**City of Portland, Oregon**  
**Bureau of Development Services**  
**Land Use Services**  
FROM CONCEPT TO CONSTRUCTION

## **NOTICE OF A TYPE II DECISION ON A PROPOSAL IN YOUR NEIGHBORHOOD**

### **CASE FILE NUMBER: LU 15-133082 AD**

**Proposal:** The owners propose a renovation and expansion of the existing house and garage, including a new second story, a new main level master bedroom at the west side of the house, new basement living area, and an art studio room attached to the existing garage at the east side of the house. The garage and art studio building will be attached to the main house with a canopy cover.

2 Side (West) Elevation  
1/4" = 1'-0"

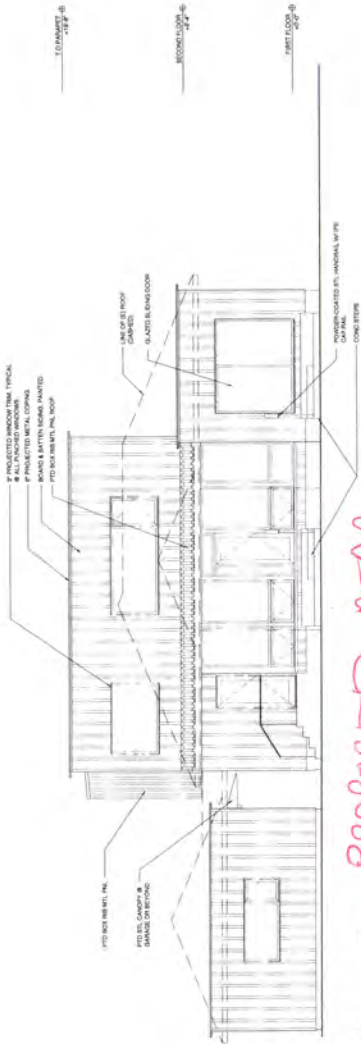
The expanded garage wall has no windows or openings in the setback area and therefore has little effect on neighbors' privacy. The master bedroom wall contains windows and does have the potential to reduce privacy. While the existing bedroom wall currently has windows, the northernmost proposed two windows have the potential to impact privacy of neighbors' backyards. To reduce potential impacts on privacy, a condition will require that these windows be removed.

**Remove windows -  
No openings here**

- A. As part of the building permit application submittal, the following development-related condition (B) must be noted on each of the 4 required site plans or included as a sheet in the numbered set of plans. The sheet on which this information appears must be labeled "ZONING COMPLIANCE PAGE - Case File LU 15-133082 AD." All requirements must be graphically represented on the site plan, landscape, or other required plan and must be labeled "REQUIRED."
- B. Remove the two northernmost windows on the west elevation of the master bedroom addition, as shown on Exhibit C-2.
